# Recall Campaign Bulletin

Campaign No. 2024040002, April 2024

Revision A: 9/6/2024

## **Check 48V Ground Connection on Passenger Seat**

**Figure 3**

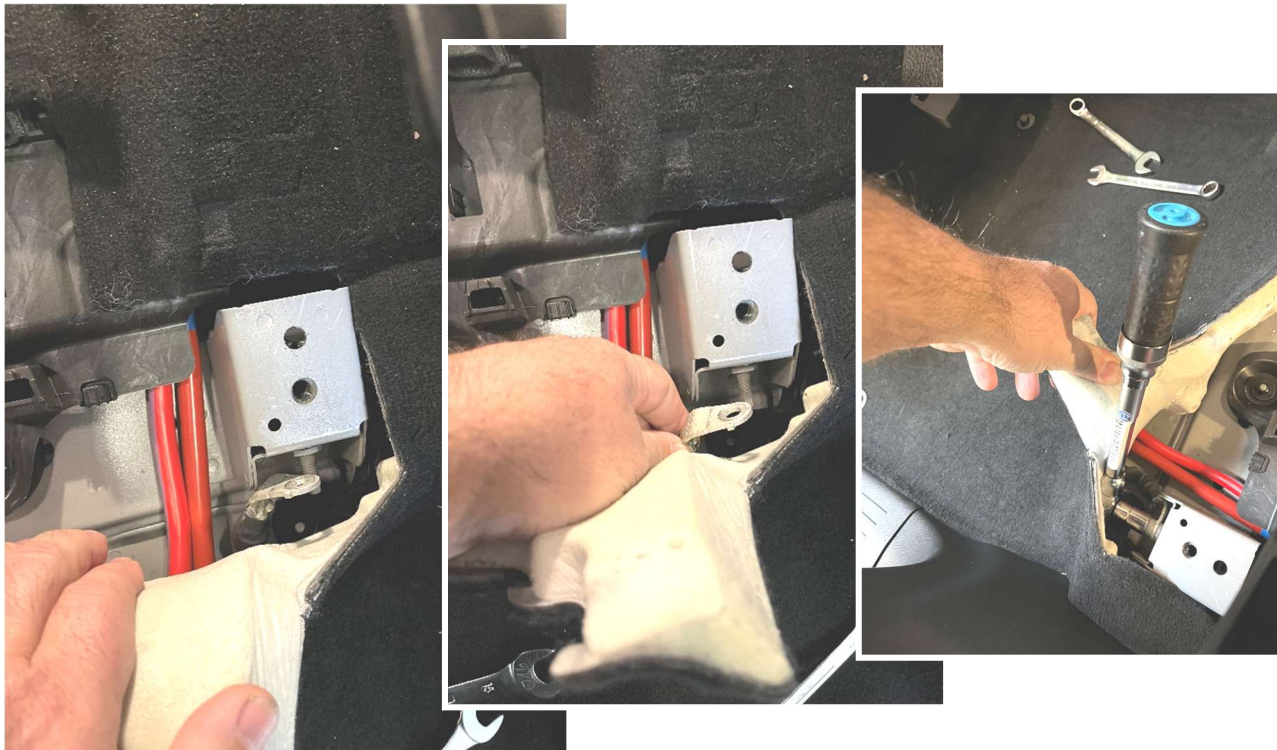
4. Disconnect and check screw connection of electrical wiring harness of 48 V on-board electrical system battery of "W106/1" ground point on body (**Figure 3**).

- i** Ensure 12 V on-board electrical system battery ground is still disconnected!
- i** Inspect ground connection for traces of thermal overload or damage (**Figure 4**).

- a. If **traces of thermal overload or damage** are **present** on the wiring harness at the "W106/1" ground point:  
Carry out **Work Procedures A and B**.  
*NOTE: Capture photos of the damage present on the wiring harness to be included in Warranty claim*
- b. If **traces of thermal overload or damage** are **not present** on the wiring harness at the "W106/1" ground point:  
Carry out **Work Procedure B**.

Figure 5

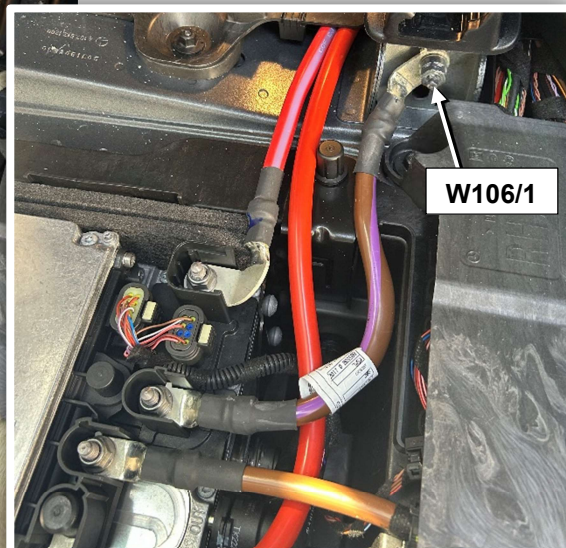
1. Replace electrical wiring harness from "W106/1" ground point to 48 V on-board electrical system battery (**Figure 5**).

Thoroughly clean area affected by thermal overload or damage.

If the ground bolt also displays traces of thermal overload or damage, the ground bolt must be replaced.

See **AR60.00-P-0100A** "Attach ground point to body" (please take the bolt part number from here).

If traces of thermal overload or damage are present on the surrounding component parts, such as the floor covering, these component parts must be replaced.
